OFFICER'S REPORT FOR:

**Proposed Waimakariri District Plan: Ranga waka - Transport (TRAN)
Proposed Waimakariri District Plan: Transport**

Andrew MacLennan – Consultant Planner

21 July 2023 (updated 18 August 2023)

Figure 1: Approach Sight Triangles for Level Crossings with "Stop" or "Give Way" Signs

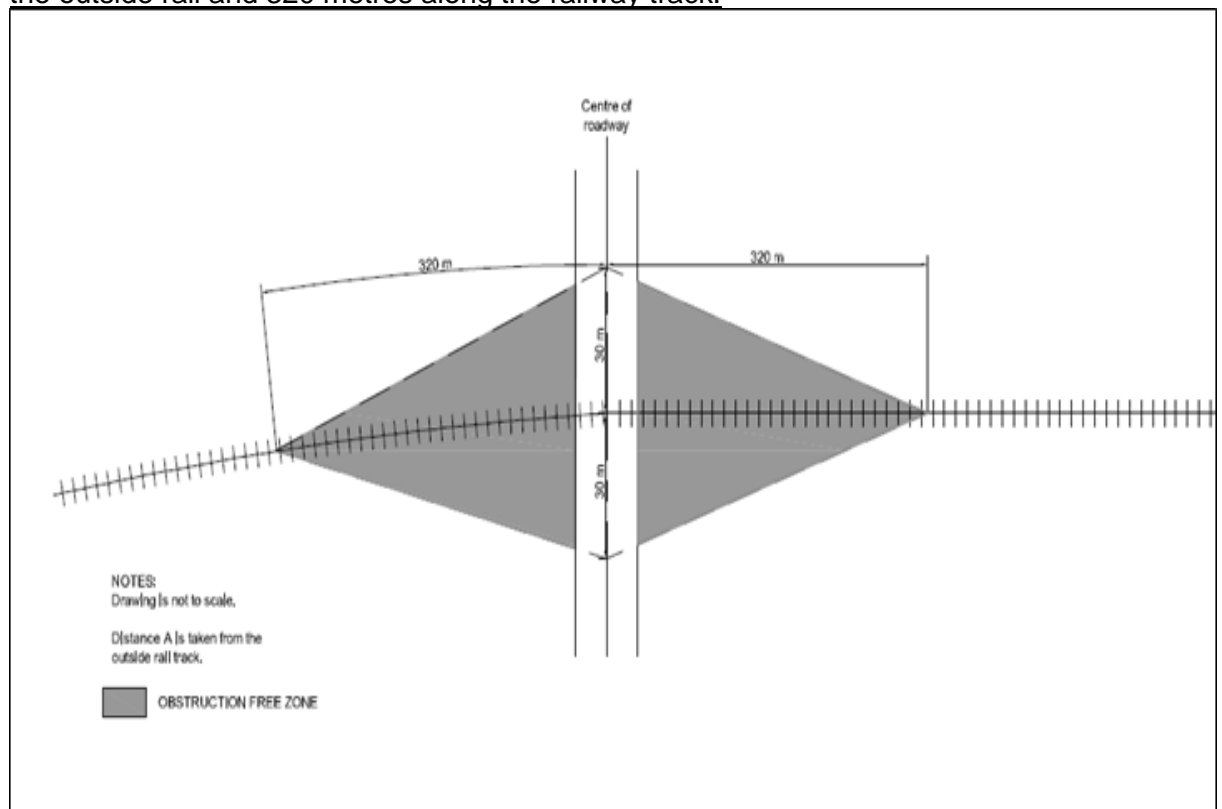
Approach sight triangles at level crossings with Stop or Give Way signs ^{85 86}

On sites adjacent to rail level crossings controlled by Stop or Give Way Signs, no building, structure, road intersections, vehicle crossings or vegetation shall be located within the shaded areas shown in Figure 1. These are defined by a sight triangle taken 30 metres from the outside rail and 320 metres along the railway track.

Figure 2: Restart Sight Triangles for all Level Crossings

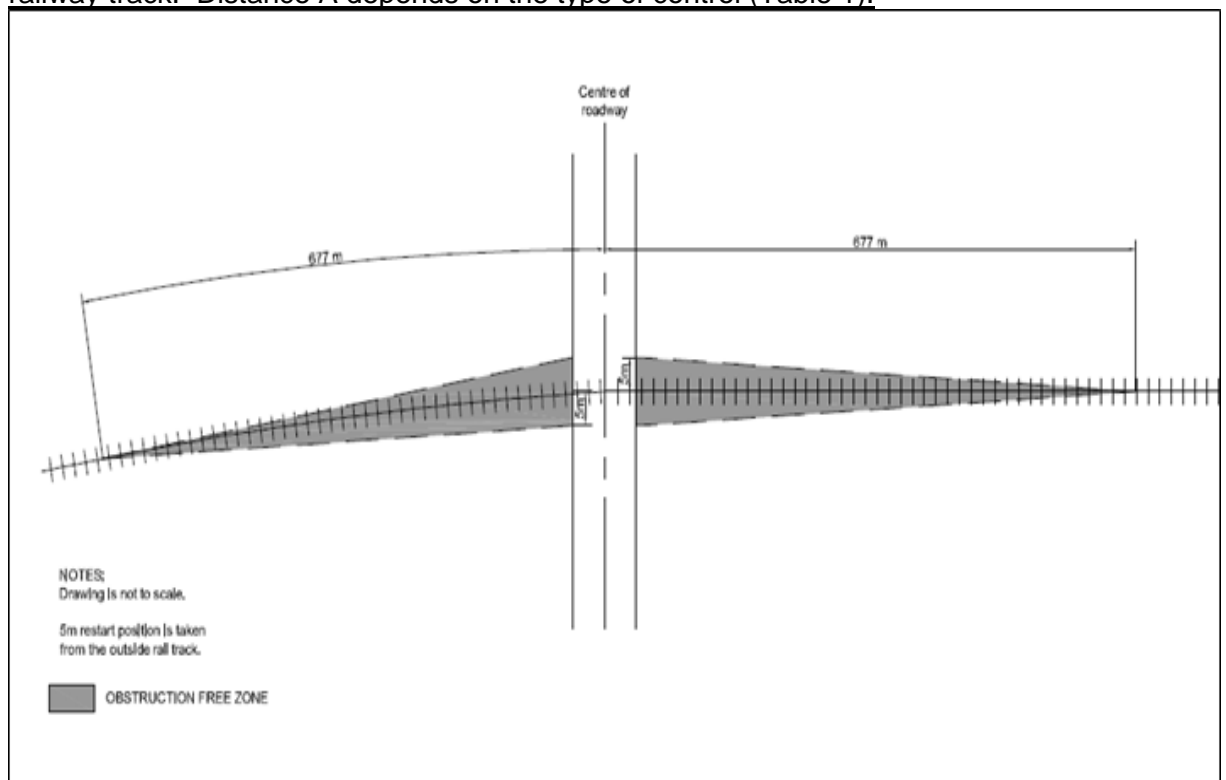
Restart sight triangles at level crossings

On sites adjacent to all rail level crossings, no building, structure, road intersections, vehicle crossings or vegetation shall be located within the shaded areas shown in Figure 2. These are defined by a sight triangle taken 5 metres from the outside rail and distance A along the railway track. Distance A depends on the type of control (Table 1).
